1985 RX-7 & 1986 B2000

SUBJECT Transmission Front Bearing Modification.

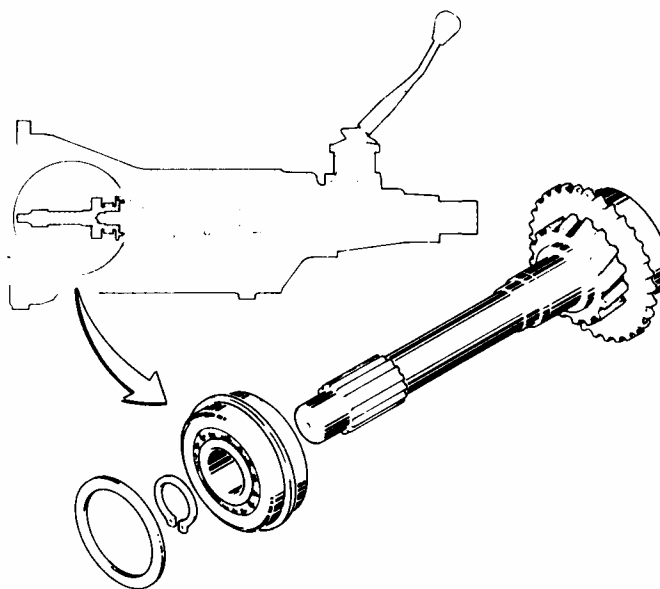
The ball bearing of the main drive gear has been changed to a specially heat treated bearing in order to further improve the durability of the transmission.

PART NUMBER		DESCRIPTION	INTERCHANGEABILITY
NEW	OLD		
M502 17 295A	M502 17 295	Ball Bearing	NEW → OLD
